The following information is submitted pursuant to the requirements of 49 CFR 573.6 as it applies to a determination by General Motors of a safety defect involving certain 2005 Buick LaCrosse vehicles.

**SUBJECT: BRAKE PEDAL PUSHROD RETAINER**

**MODELS: 2005 BUICK ALLURE, LACROSSE**

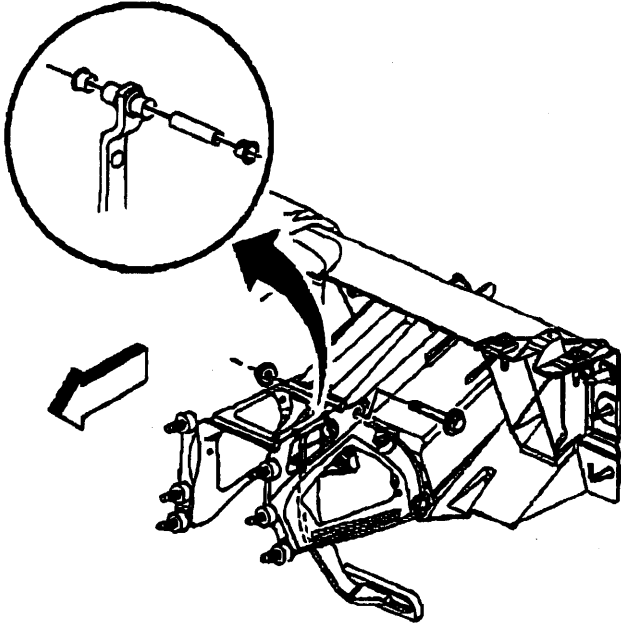
**Important: This is opposite the way that the original bushing was installed. The retaining flange should be on the retaining clip side of the brake pedal pushrod.**

1. Unplug and remove the brake pedal position sensor.
2. Remove the brake pedal pushrod retaining clip from the brake pedal.
3. Remove the brake pedal pushrod and bushing from the brake pedal.
4. Coat the new bushing with white lithium grease (P/N 12345996) before installation.
5. Install a new bushing into the brake pedal pushrod from the outboard side.

6. Install the brake pedal pushrod and bushing to the brake pedal.
7. Install a new brake pedal pushrod retaining clip to the brake pedal.
8. Install a new brake pedal position sensor.

Tighten the screw to 2.0 N·m (18 lb in).
